Minnesota Center for
Environmental Advocacy

August 23, 2022

RE: *MCEA, Sierra Club, Clean Wisconsin, and Honor the Earth Comments on Supplemental Environmental Assessment Dairyland Power Cooperative's Proposed Nemadji Trail Energy Center*

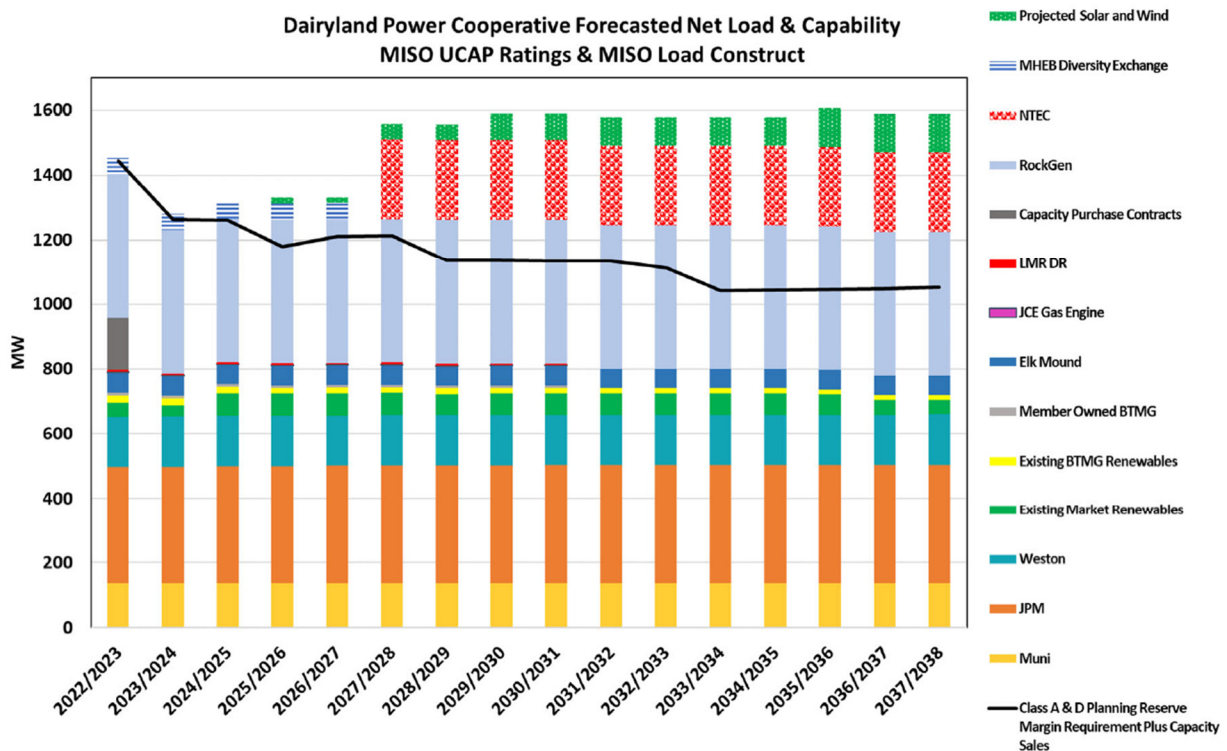
A threshold question is raised by a recent regulatory filing by Dairyland: does the utility need NTEC at all? Dairyland recently submitted a document to the Minnesota Public Utilities Commission that appears to indicate that it already has far more capacity than it needs.²⁷⁰ The figure below is taken from that filing.

The black line shows Dairyland’s planning reserve margin requirement plus its capacity sales. Even including those sales, it shows that Dairyland has more than enough capacity to meet its needs without NTEC. Much of that capacity is represented by RockGen, a 503 MW gas plant that Dairyland purchased in December of 2021, after the initial EA and prior to the Supplemental EA. Dairyland’s website explains that RockGen will help “support intermittent solar and wind resources.”²⁷¹ Dairyland similarly describes the purpose of NTEC as, in part, “to facilitate the addition of new renewable energy sources to the power portfolio by complementing their
